HISTORIC AND DESIGN REVIEW COMMISSION

September 20, 2017

HDRC CASE NO: 2017-476
ADDRESS: 411 MUNCEY
LEGAL DESCRIPTION: NCB 1654 BLK B LOT N 50 FT OF 16
ZONING: R-5 H
CITY COUNCIL DIST.: 2
DISTRICT: Dignowity Hill Historic District
APPLICANT: Frank Telles
OWNER: Michael and Karina Bostwick
TYPE OF WORK: Construction of a rear and side addition, window replacement, exterior modifications, installation of new porch columns

**REMODEL
FLOOR PLAN**
SCALE: 1/8" = 1'-0" FOR DIT SHEET
SCALE: 1/4" = 1'-0" FOR 22X34 SHEET

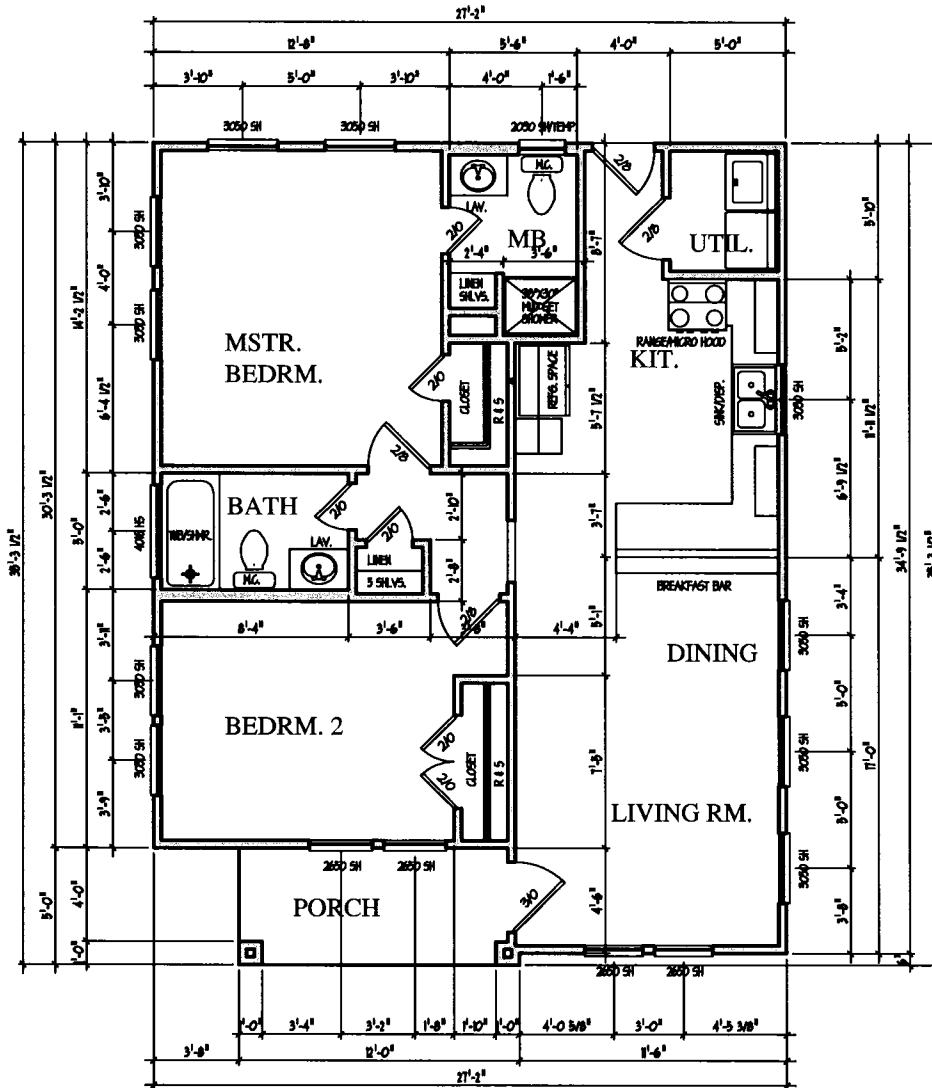
- b. SIDE ADDITION: MASSING AND FOOTPRINT – The applicant has proposed to construct a side addition to measure approximately 40 square feet. The location of the addition will enclose an existing doorway and result in a visual extension of the front façade to the west. Staff finds the massing generally consistent with the Guidelines, but does not find the location appropriate.

- c. SIDE ADDITION: SETBACK – According to Guideline 1.A.iv, a setback or recessed area should be utilized for a new addition to provide a clear visual distinction between old and new building forms. The side addition is not set back from the primary structure’s front façade. Staff finds the proposal inconsistent with the Guidelines.

- h. REAR ADDITION: MASSING AND FOOTPRINT – The applicant has proposed to construct a rear addition to the primary structure to be approximately 80 square feet. According to the Historic Design Guidelines, additions should be located at the side or rear of the property whenever possible. Additionally, the guidelines stipulate that additions should not double the size of the primary structure. The addition is approximately one eighth the size of the overall footprint of the existing home. Staff finds massing and footprint size generally consistent with the Guidelines.

- j. WINDOW OPENING REMOVAL – The proposed additions require the removal of several existing window openings, including at least three on the west elevation and one on the rear elevation. The applicant has indicated that all windows are to be replaced. Guideline 3.C.i in the Historic Design Guidelines for Additions encourages the salvage and reuse of historic materials, where possible, that will be covered or removed as a result of an addition. Staff finds the proposal inconsistent with the Guidelines.

Item 1, Staff does not recommend approval of the side addition based on findings a through g.

Item 2, Staff does not recommend approval of the rear addition based on findings g through i. Staff finds that the general footprint is appropriate, but finds that the modified roofline needs to be subordinate to the primary historic roofline. with

Item 3, Staff does not recommend the modification of the existing left window openings based on finding j.

A-1

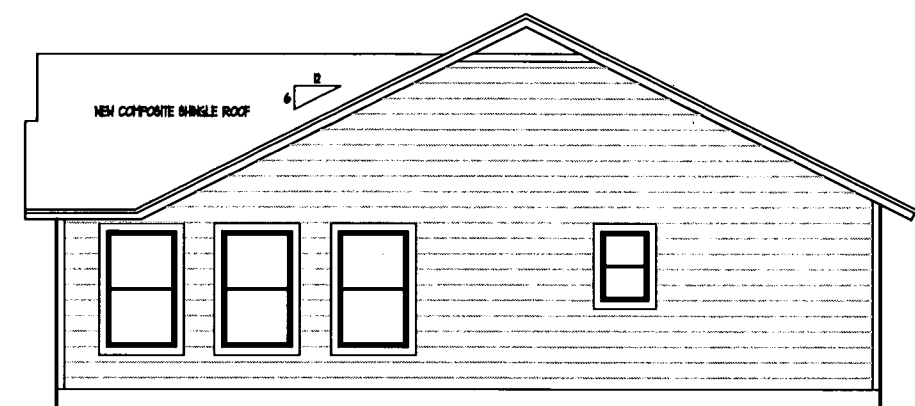
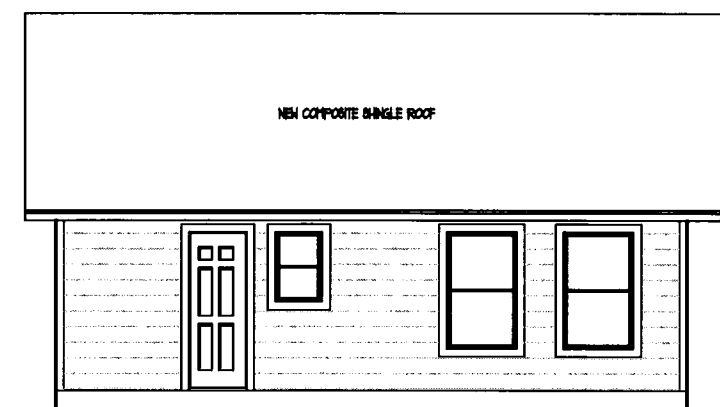
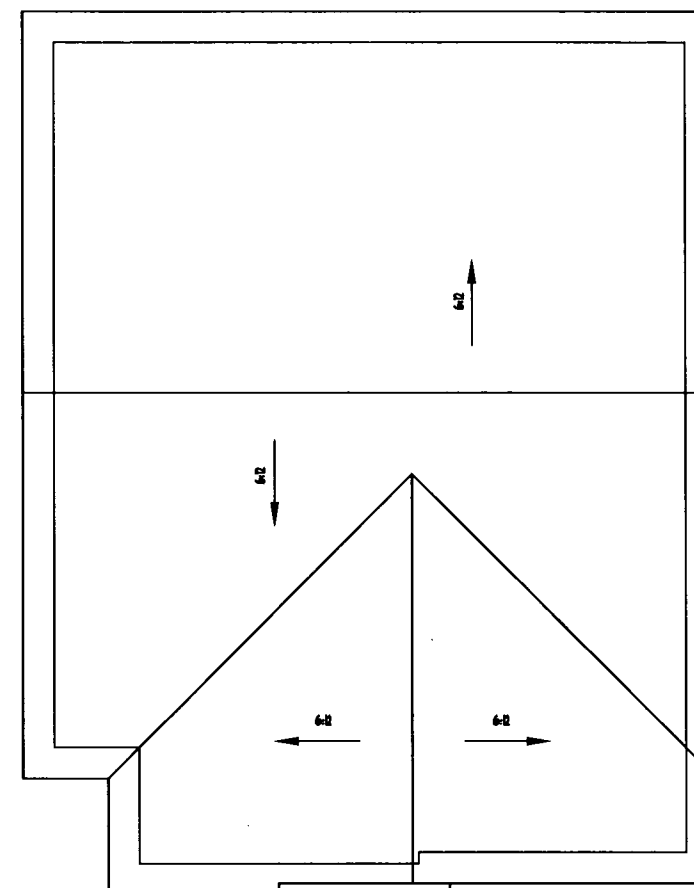
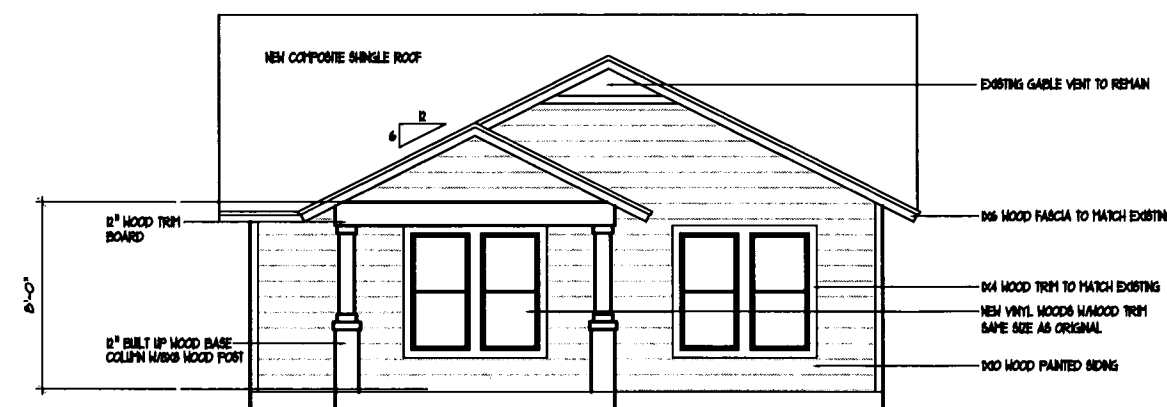
- d. SIDE ADDITION: ROOF FORM – The proposed addition will require the modification of the existing roof form. The proposal will incorporate a new side gable primary roof that extends above the ridgeline of the existing historic structure. According to the Historic Design Guidelines, the height of side or rear additions should be limited to the height of the original structure. Staff finds the proposal inconsistent with the Guidelines.

- e. SIDE ADDITION: MATERIAL TRANSITIONS – According to Guideline 2.A.v for additions, rear additions should utilize setbacks, a small change in detailing, or a detail at the seam of the historic structure and addition to provide a clear visual distinction between old and new building forms. Staff finds the proposal to use woodlap siding to match the existing appropriate for the historic structure. However, this proposed addition does not utilize a clear setback strategy, and staff has not seen a proposal to visually differentiate the historic structure’s material from the new addition.

- i. REAR ADDITION: SETBACK AND TRANSITIONS – According to Guideline 2.A.v for Additions, rear additions should utilize setbacks, a small change in detailing, or a detail at the seam of the historic structure and addition to provide a clear visual distinction between old and new building forms. The proposed addition is not set back from the existing structure and does not employ a material transition or small change in detail. Staff finds the proposal inconsistent with the Guidelines.

- k. INSTALLATION OF NEW WINDOWS – The applicant has proposed to install new windows on the right façade

of the home. The Historic Design Guidelines recommend avoiding new openings on the facades that engage the public right-of-way. Staff finds that the proposed windows feature proportions and configurations that are consistent with the primary structure and historic precedents in the district, but does not find the use of vinyl windows to be appropriate for the historic structure.

Item 4, Staff recommends approval of the new window opening installations on the right façade of the home based on finding k with the following stipulations:

- i. That the applicant installs new wood windows in lieu of the proposed vinyl. Meeting rails must be no taller than 1.25” and stiles no wider than 2.25”. There should be a minimum of two inches in depth between the front face of the window trim and the front face of the top window sash. This must be accomplished by recessing the window sufficiently within the opening or with the installation of additional window trim to add thickness. The final specification should be submitted to staff for review prior to the issuance of a Certificate of Appropriateness.
